Flight Procedures Cover Page	Task Action: FLIGHT CHECK	Task Type: IAP	Estimated Chart Date: 07/09/2026	APWS Task ID: CF93DC8AC1B54463B00979CA2A8723B0	APWS Project ID: FAE2C80AB3D543D6A2BD8E5D7A9093F1
Procedure: RNAV (GPS) RWY 24 AMDT 1		Enroute: NO	Specialist: Shedd, Steven		Agreement Number:
Airport ID: KPOU			Airport City: POUGHKEEPSIE		State: NY
Facility ID:	Facility Type:	Flight Inspection Remark Type: New FC Slot

PROCEDURE: RNAV (GPS) RWY 24 AMDT 1		AIRPORT NAME: HUDSON VALLEY RGNL		AIRPORT ID: KPOU	SPECIAL CONTROL NO: YG-04-143-26
FAC ID: KPOU24.01		CITY: POUGHKEEPSIE		ST: NY	ORIG CHART DATE: 07/09/2026
DFL TYPE: PROC/G	THIRD PARTY: <input type="checkbox"/> YES	EST. TIME ON SITE: 0.5	REIMB. NUMBER:	PTS TASK ID: CF93DC8AC1B54463B00979CA2A8723B0

Subject: Approval Request: Hudson Valley Rgnl, Poughkeepsie, NY (KPOU) RNAV (GPS) RWY 24

RNAV (GPS) RWY 24

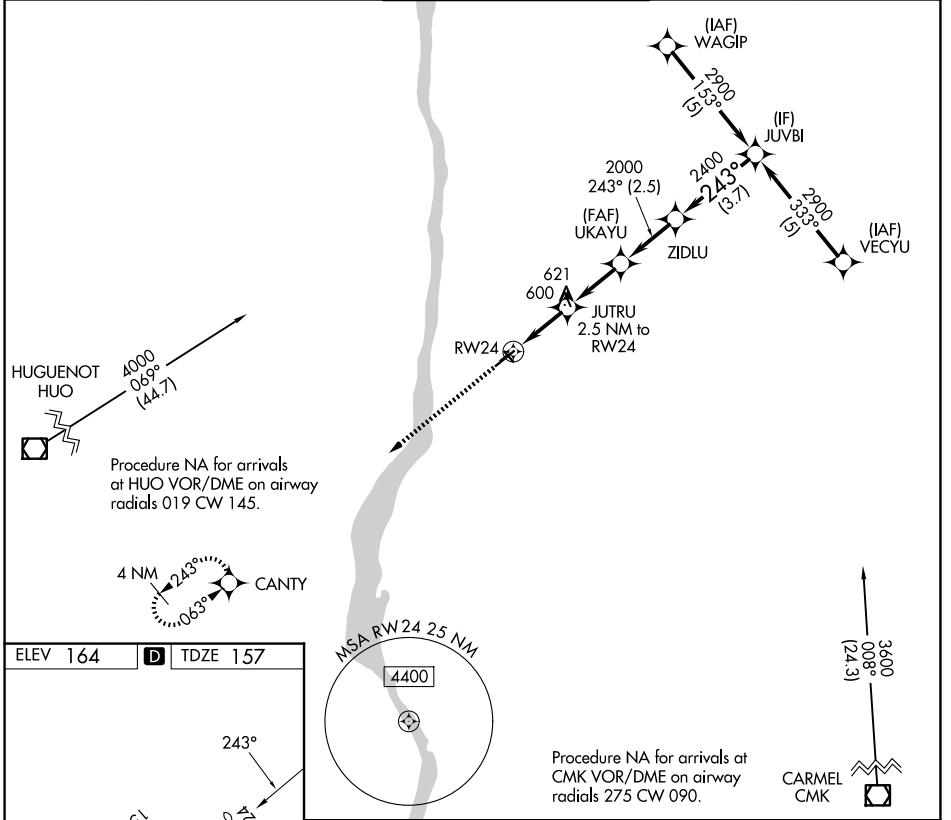
APPROVAL LETTER TO USE THE VGSI TO MITIGATE UNLIT 20:1 RWY 24 PENETRATIONS REQUESTED.

FLIGHT INSPECTOR REMARKS:
Tower left of centerline. Hill on approach. No vertical guidance for 90 percent of circle. Unsat for human factors.

The following obstacles penetrate the RWY 24 straight-in 20:1 visual and circling approach surface to RWY 24.

Request approval to utilize the visual guidance slope indicator (VGSI) of RWY 24 to mitigate unlit 20:1 visual straight-in surface and circling penetrations, per FAA Order 8260.3G, 3.3.2 c.(4)(b)1. A procedure note will be added “CHART NOTE: STRAIGHT-IN OR CIRCLING RWY 24 AT NIGHT, OPERATIONAL VGSI REQUIRED, REMAIN ON OR ABOVE VGSI GLIDEPATH UNTIL THRESHOLD.”
